Sequoyah Nuclear Plant, Unit 1  
Facility Operating License No. DPR-77  
Docket No. 50-327

**Subject: Response to Nuclear Regulatory Commission (NRC) Third Request for Additional Information Regarding the Heavy Load Lifts and UHS One Time Change in Support of Unit 2 SGRP (TAC NO. ME7225)**

#### RESPONSE TO NRC THIRD REQUEST FOR ADDITIONAL INFORMATION REGARDING THE HEAVY LOAD LIFTS IN SUPPORT OF UNIT 2 SGRP

Figure 3-259. Annual probability of exceedance of peak ground acceleration: Sequoyah site.

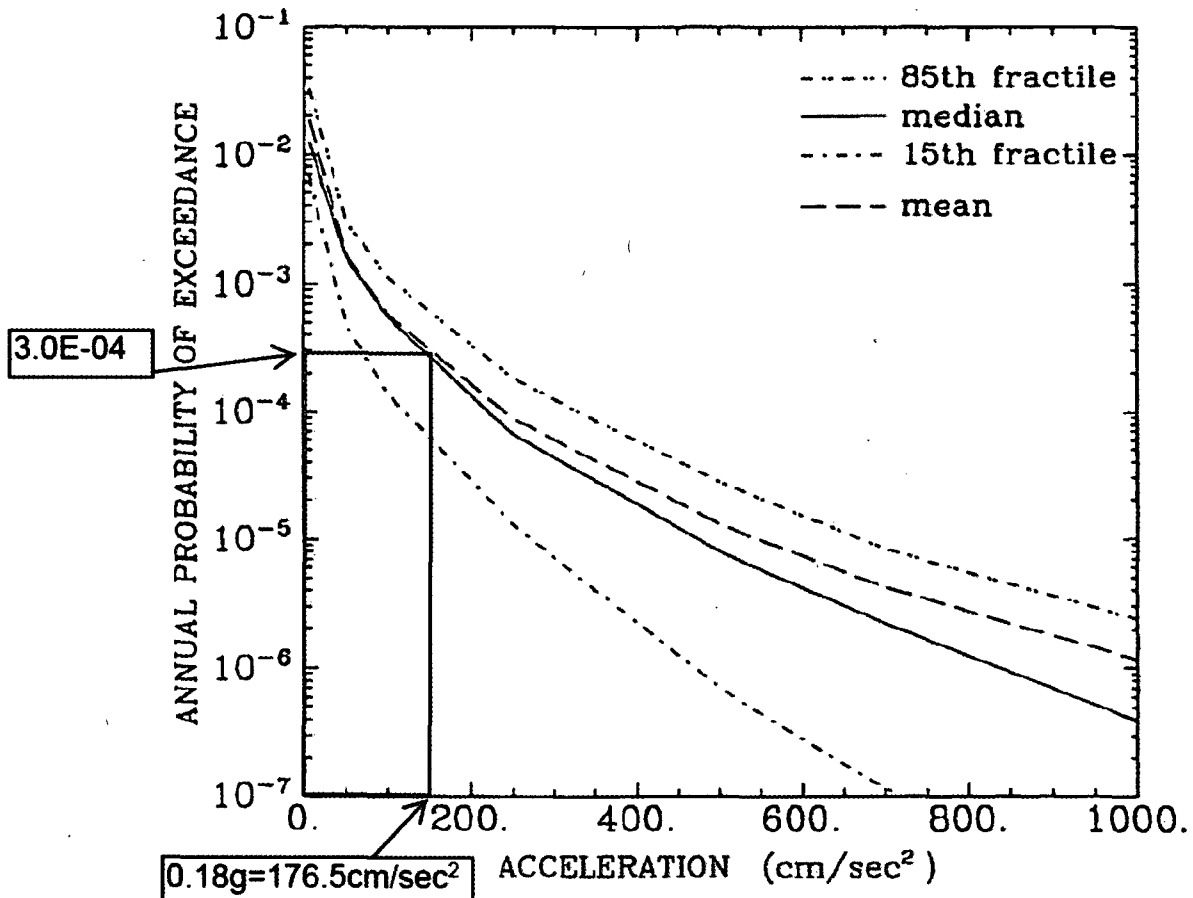
*Page 31 of the submittal dated September 29, 2011 [Agency-wide Document Access and Management System (ADAMS) Accession No. ML11273A169] (submittal), states that, "the OLS [outside lift system] will not collapse or drop a load while loaded or unloaded during the SSE." What is the probability of a seismic event exceeding the SSE [safe shutdown earthquake] (or, alternatively, the strength of the OLS) while the OLS is loaded? If the risk from a seismic event could be significant compared to the random lift drop, please include this risk in your change in core damage frequency [CDF], and large early release frequency [LERF] estimates.*

The Sequoyah Nuclear Plant Updated Final Safety Analysis Report (UFSAR), Section 2.5.2.4, defines the Safe Shutdown Earthquake (SSE) maximum ground acceleration of 0.18 g or 176.5 cm/sec<sup>2</sup>. Using the following figure from the EPRI report NP-6995-D, "Probabilistic Seismic Hazard Evaluations at Nuclear Plant Sites in the Central and Eastern United States: Resolution of the Charleston Earthquake Issue," the frequency of a seismic event exceeding the SSE is 3.0E-04 per year.

Each load lift is estimated to take one hour to complete. Since there are eighteen load lifts, the total time during which the OLS will be loaded is eighteen hours. To calculate the probability of having a beyond SSE event while the OLS is loaded, the frequency of the seismic event exceeding the SSE ( $3.0E-4$ ) was multiplied by the duration, in years, of the OLS being loaded ( $18 \text{ hrs} / 8760 \text{ hrs per yr}$ ). The calculated probability of this event is  $6.16E-07$ . This probability is well below the annual probability of having a random lift load drop, which is  $1.017E-03$ , and is therefore not included in the Core Damage Frequency (CDF) and Large Early Release Frequency (LERF) analysis.
